Title: Advisory Committee on Reactor Safeguards
 Reliability and PRA Subcommittee
 Open Session

Date: Wednesday, May 2, 2018

Opening Remarks.....	4
Project Status Overview.....	7
LPSD PIRT NUREG/CR.....	57
Public Comment.....	183
Adjourn.....	187

AHP Hierarchies Developed for the PIRT

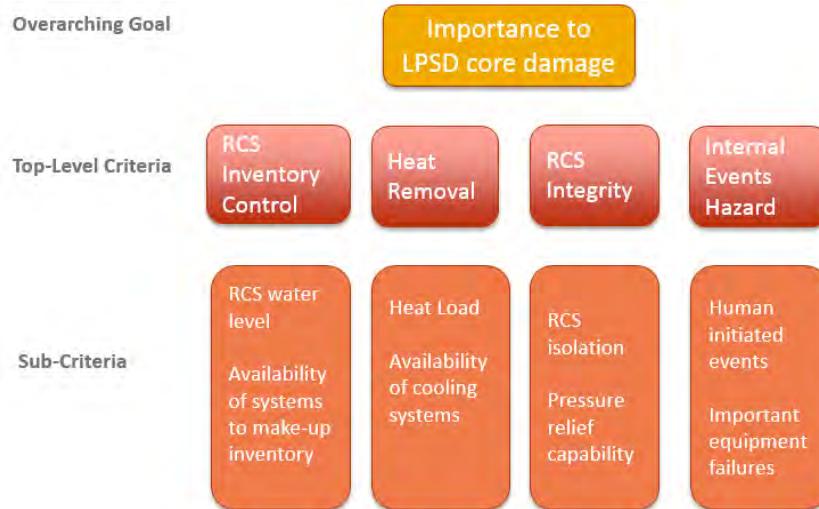
21 The thing that bothers me about it is that
22 you're asking the experts to say at that level how
23 important are fires, let's say, in Plant Operating
24 State 7, as compared to inventory control in Plant
25 Operating State 7.

1 Because that's what you're asking them to
2 do and to me, I don't know how to do that. I don't
3 know how to compare fires in Plant Operating State 7,
4 weighting now 12479, compared to inventory control in
5 Plant Operating State 7, or if I'm now biased by the
6 way you've set up the process.

18 MR. COLES: Well, we did talk about this,
19 they did not want to remove it. They felt like it was
20 --
